# POWER SYSTEM MODEL GUIDELINES

DRAFT REPORT AND DETERMINATION

# NOTICE OF SECOND STAGE CONSULTATION – POWER SYSTEM MODEL GUIDELINES

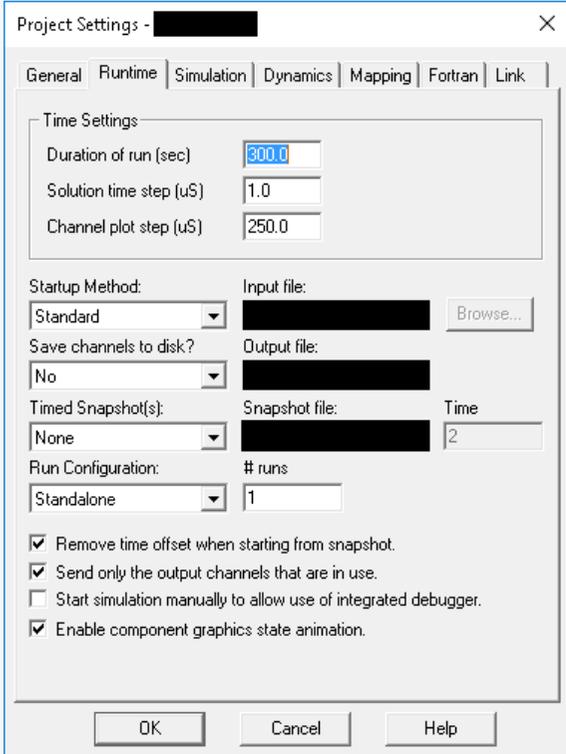
AEMO is not aware of any practical experience or reliable evidence to support the statements that "The greater the complexity of the power system model the more likely it is to produce abnormal or inconsistent results", or that "Using large, complex EMT modelling will make it extremely difficult to achieve reasonable stable results over the longer time periods that are asked for". A more detailed response is included in AEMO's response to issue 39. As discussed in response to issue 47, AEMO has been running the full-scale PSCAD™/EMTDC™ of the South Australian *power system* for one minute's worth of simulation. A small number of abnormal responses of specific models were fixed in collaboration with the model providers (OEMs) in conjunction with the respective *Generators*. The current version of AEMO's full-scale PSCAD™/EMTDC™ model of the South Australian *power system* does not show any model non-convergences.

AEMO is pleased to note that some of the highest quality simulation models provided to it, include models of all *protection systems* of relevance and significance by default.
